PLANNING & HIGHWAYS COMMITTEE
WEDNESDAY, 29TH May 2019.
UPDATE REPORT.

1. 10/18/1094: Proposed Lidl Store – land at Furthergate Works, Blackburn.

2. 10/18/1153: Outline application for proposed 9no. dwellings - Land at Moorthorpe Cottage, Park Road, Darwen.

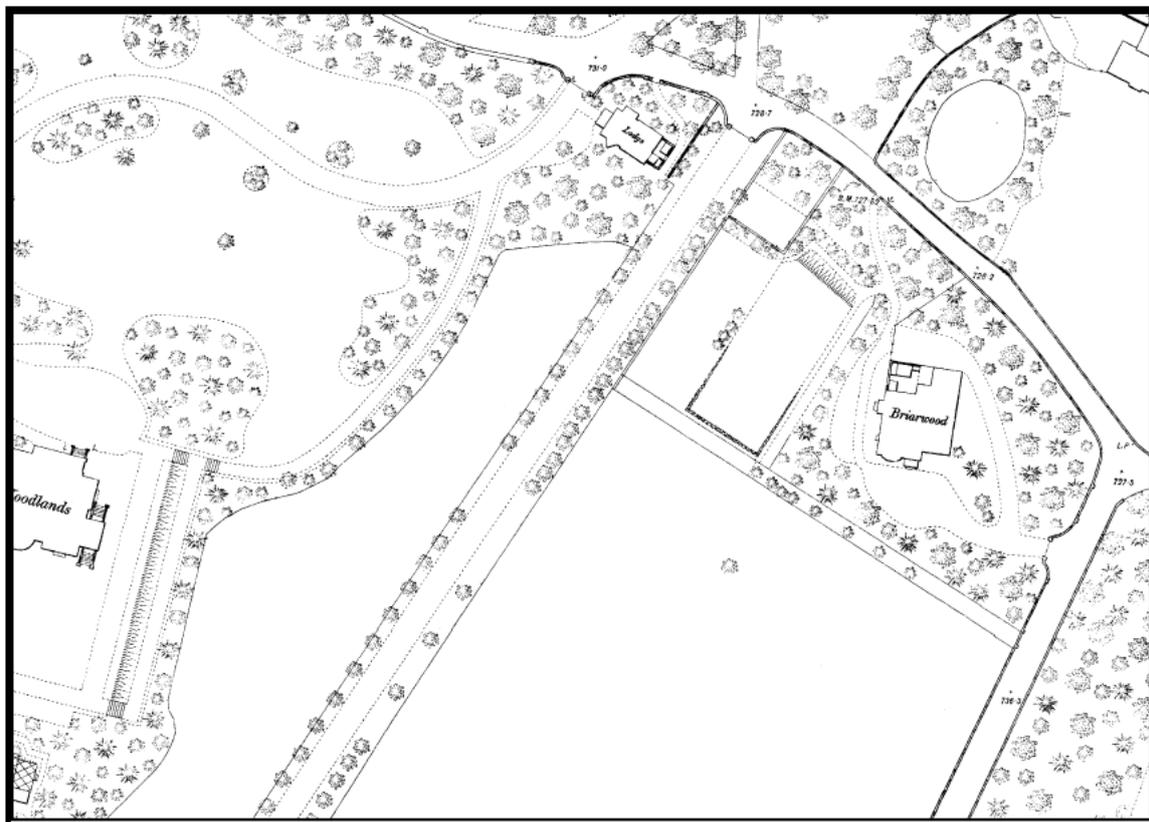
1) Access and layout-You have failed to mention in your report the measurement from the top of the gate post (see enclosed) which is only 3.5 mtrs wide. Indeed the right hand ornate top has been knocked off twice in the last 12 months by relatively small vans coming into the access road from the left.

2) Access and layout-You have failed to mention in your report the measurement of the road round the 90 degree turn which is 3.8 mtrs wide (see enclosed) and it looks as though you have only taken measurements on the straight part of the road up to the corner which does

Whilst the Committee Report acknowledges the limited width of the private access, setting out interval widths, the minimum width towards the top of the gate posts of circa 3.5m is now acknowledged. Notwithstanding this measurement, the proposal in this regard is considered acceptable, on account that a standard refuse vehicle has a maximum width of 2.6m. The Council's Environmental Services consultee has re-iterated no objection to the proposal.

A further representation received on the 28th May 2019 queries the width of the private access road along its length; in particular the measurement around the 90 degree turn. The width at this point, in the professional judgement of the Council's Highways consultee, is considered to be adequate to cater for large vehicles.

02 TownPlan, Durwin, L101200000 and P1000000 / 1:500 2019

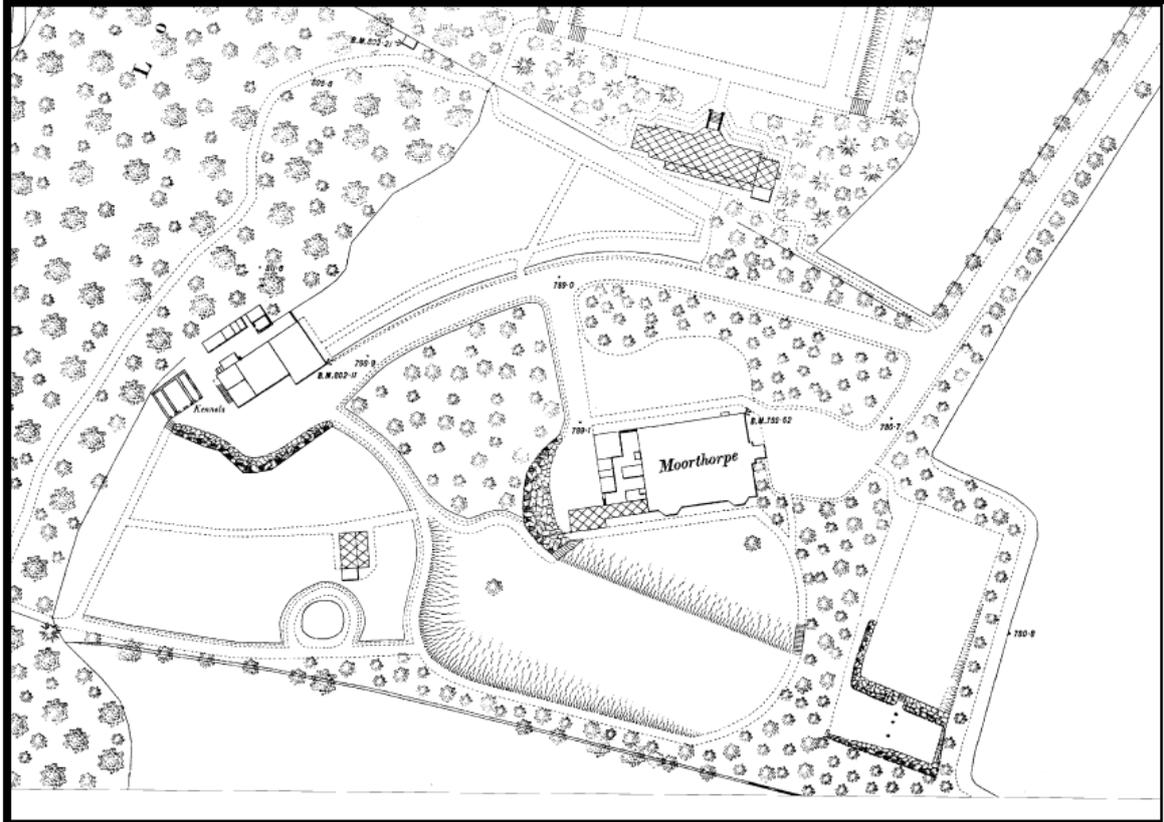
I am probably too late for tomorrow's meeting, however I thought it would be worth sending this. Attached are two plans from the 1st Edition OS Map 1891-1892. As you can see, the access road was in place at that time, and the width is shown as wide as some of the more major roads in the area. Over time further houses off the access drive were developed and the access has coped with the accumulation of development. I am sending this as a couple of the Committee members visited site today and commented on the road. It seems like the neighbours have done their best to cover up the true extent of the width of the access track on the ground, whereas it should be as shown on the attached plan.

A representation from the applicant's agent, received on the 28th May 2019, provides historic plans extracted from the 1st Edition OS Map 1891-1892, which shows the private access road in situ, with a width consistent with some of the major roads in the area. It is claimed that, over time, the width has been allowed to narrow as a consequence of vegetation growth, thereby concealing its true extent.

Highway's concern at the access arrangements along the private road is re-iterated. Concern is not, however, considered to be sufficient to justify refusal of the application on highway efficiency / safety impact; particularly in view of the sites allocation as a *Development Opportunity*; in accordance with the Local Plan Part 2.
